AGENDA – WORKSHOP OF THE PLANNING AND ZONING COMMISSION OF THE CITY OF PEARLAND, TEXAS, TO BE HELD OCTOBER 15, 2007 AT 8:30 P.M., IN THE COUNCIL CHAMBERS, CITY HALL, 3519 LIBERTY DRIVE, PEARLAND, TEXAS

- 1. COMMISSION INPUT AND DISCUSSION:** REGARDING A PROPOSED PLANNED DEVELOPMENT (pd) LOCATED NORTH OF PEARLAND PARKWAY AND WEST OF FM 518. *Ms. Lata Krishnarao, Planning Director.*

**Planned Development District Application
for
Pearland Commons
a Trammell Crow Company Retail Development**

1 PRELIMINARY SITE PLAN

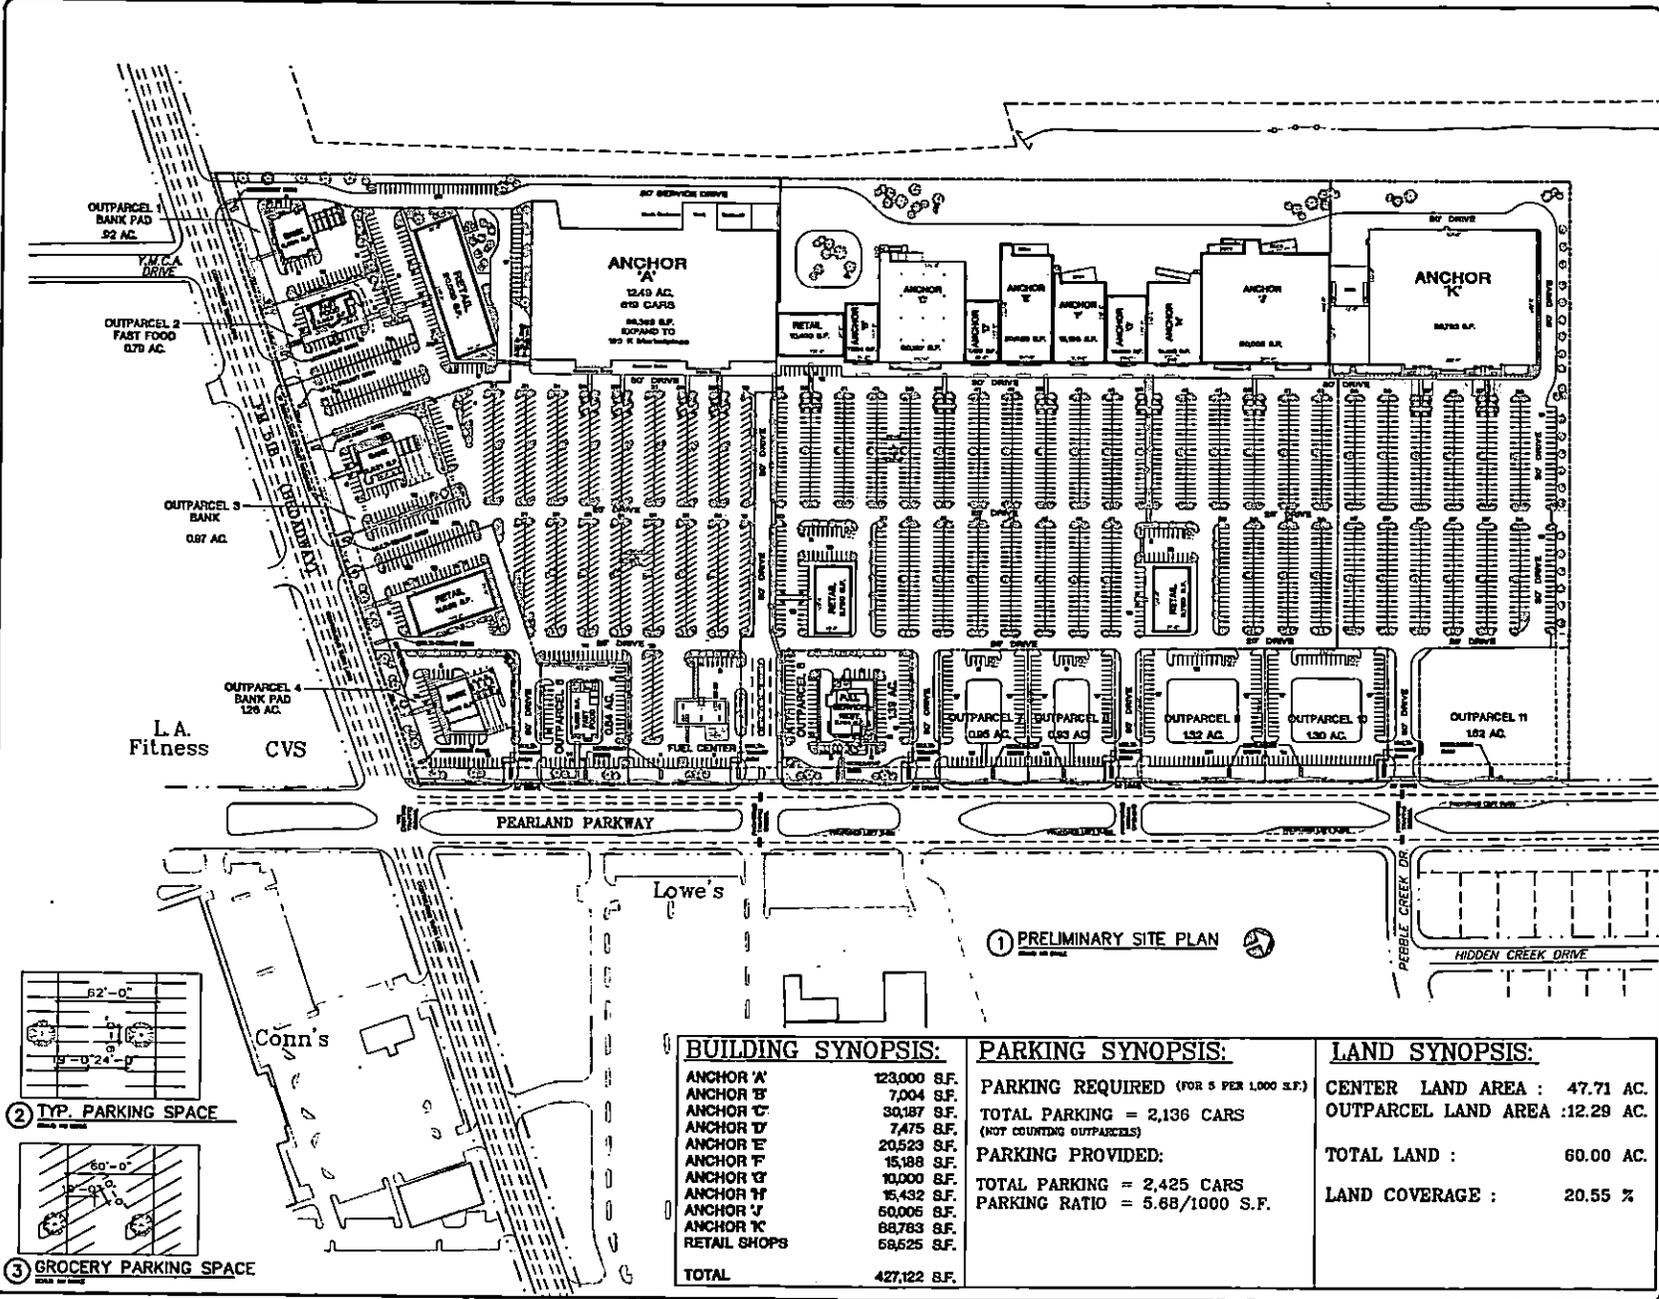
1. Variances form signage requirements – details have not been specified.
2. Landscaping requirements –
 - a. Allow the entire tract to be considered as one development. However an overall landscaping plan has not been provided.

- b. Reduce the tree requirement for parking lots from 1" caliper for every 5 spaces to 1" for every 10 spaces.
 - c. Locate the 25' foot buffer inside the fence within the property.

- d. Waiver from tree spacing requirements along streets and within parking lots. Currently parking lots need islands. This waiver would allow them to cluster trees in one area and not provide islands.

- e. Waiver from locating 50% of trees along the front. This is a specify requirements for the Corridor Overlay Districts (COD).
3. Reduction in lot sizes from 22,500 s.f. to minimum of 7,000 s.f.

4. Masonry fence requirement be waived along adjacent residential zoned land and for property adjacent to the ditch.
5. Smaller parking space/ aisles than that required by the UDC for angled parking. It is not clear exactly what the variance is.

6. Allow an aggregate parking count for the entire development. A ratio has not been mentioned.
7. Monument signs and sidewalks are included in landscape area calculations.

8. Bicycle parking be reduced to 2% of total parking spaces from 5%.
9. Minimum caliper for shade trees be 2" instead of 3". It is 2" now.
10. Exemption from build façade articulation requirement.

11. Exemption from 25% transparency requirement.
12. Taller light poles that allowed by the COD. COD requires that poles not be taller than the building being served.

13. Exemption from the requirement to underground existing above ground utilities.
14. Allow above ground distribution lines in the rear and along the northern side.

It is not clear how the development will meet the purpose of the Corridor Overlay District – "___ is intended to help the City exercise greater control over the aesthetic, functional and safety characteristics of development along newly constructed major thoroughfares within the City where higher development standards can effectively enhance the City's image as a desirable place to live, work, and shop."

Staff is in favor of a PD for this tract of land. In the past, PDs in Pearland have encouraged flexibility while resulting in higher standards of development with greater architectural controls, higher levels of amenities, enhanced pedestrian connectivity, strong sense of place, meaningful public places with visual focal points, creative treatment of detention and other amenities, and larger open spaces. A PD that addresses these issues will allow the 60 acre tract to be developed in a unified way and to provide features that might not be possible in traditional development. However it is not clear how this PD achieves those objectives.
